Project	IEEE 802.16 Broadband Wireless Access Working Group < http://ieee802.org/16 >	
Title	Correction to Rx SNR, Rx sensitivity, and Tx Relative Constellation Error for OFDM and OFDMA systems.	
Date Submitted	2005-08-03	
Source(s)	Darcy Poulin [SiGe Semiconductor], Paul Piggin [Cygnus Multimedia Communications], Ran Yaniv [Alvarion], Dov Andelman [Intel]	Voice: [613-820-9244 x274] Fax: [Fax Number] dp@sige.com , ppiggin@cygnuscom.com
Re:	IEEE P80216_Cor1_D4	
Abstract	Correction to Rx SNR, Rx sensitivity, and Relative Constellation Error for OFDM and OFDMA systems.	
Purpose	The Rx SNR values in 802.16-2004 are incorrect. As a result, relative constellation error (EVM) and Rx sensitivity are also in error. In addition, there are many inconsistencies throughout section 8.3, 8.4, and 12.4 specifying EVM and Rx SNR. This submission attempts to resolve these inconsistencies.	
Notice	This document has been prepared to assist IEEE 802.16. It is offered as a basis for discussion and is not binding on the contributing individual(s) or organization(s). The material in this document is subject to change in form and content after further study. The contributor(s) reserve(s) the right to add,

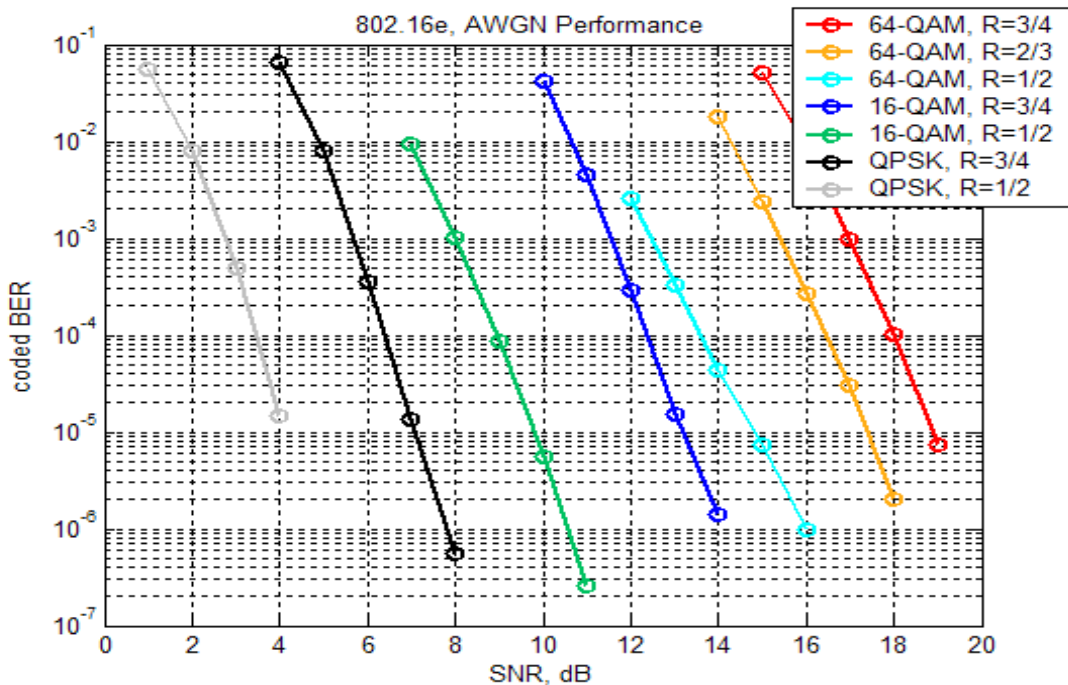
The transmitter relative constellation error (EVM) must also be changed as a result of this error correction. The Tx EVM is computed so that it is 10 dB below the Rx SNR (not including implementation loss). This is done to ensure that the transmitter has minimal effect on the overall link. For example, for 16QAM-1/2, the Rx SNR is 11.5 dB. Therefore, the required Tx EVM will be $-(11.5 + 10) = -21.5$ dB, and the Tx EVM only degrades the overall SNR by 0.4 dB (the 11.5 dB SNR will be degraded to an SNR of 11.1 dB when the transmitted signal with a EVM of -21.5 dB is applied).

For subscriber stations, we are also proposing that we cap the EVM at -30 dB. Applying a cap at -30 dB means that for the worst case 64QAM-3/4 modulation, the transmitter will degrade the overall SNR by 1.5 dB.

For base stations, we will not put a cap on EVM, so it remains at -31 dB. This will result in a worst case degradation of the SNR of 1.2 dB for 64QAM-3/4.

To summarize:

SS EVM = BS SNR + 10 dB.

This is capped at -30 dB.

BS EVM = SS SNR + 10 dB
